Interactive comment on “Integration of HVSR measures and stratigraphic constraints for seismic microzonation studies: the case of Oliveri (ME)” by P. Di Stefano et al.

Anonymous Referee #1

REVIEW OF THE MANUSCRIPT "Integration of HVSR measurements and stratigraphic constraints for the seismic microzonation studies: the case of Olivieri (ME)" by Di Stefano P. et al. (2014)

Fig. 1.

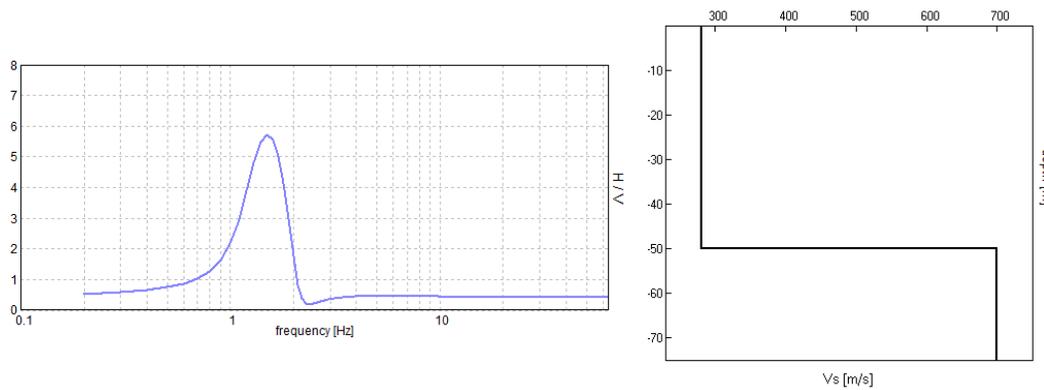
According to the Occam’s razor principle, among competing hypotheses, the one with the fewest assumptions should be selected, in absence of further information. The HVSR curve presented by the authors (p. 39, fig. 9) shows essentially a single peak at 1.4 Hz. Any HVSR curve showing N peak can be fitted by models with N+1 layer (the only exception being the presence of velocity inversions). In this case a 2 layer model is enough to fit the experimental curve (see figure below). The layer at 170 m depth proposed by the inversion procedure may also ultimately prove correct, but - in the absence of information from alternative sources that we do not have here - the fewer assumptions that are made, the better.
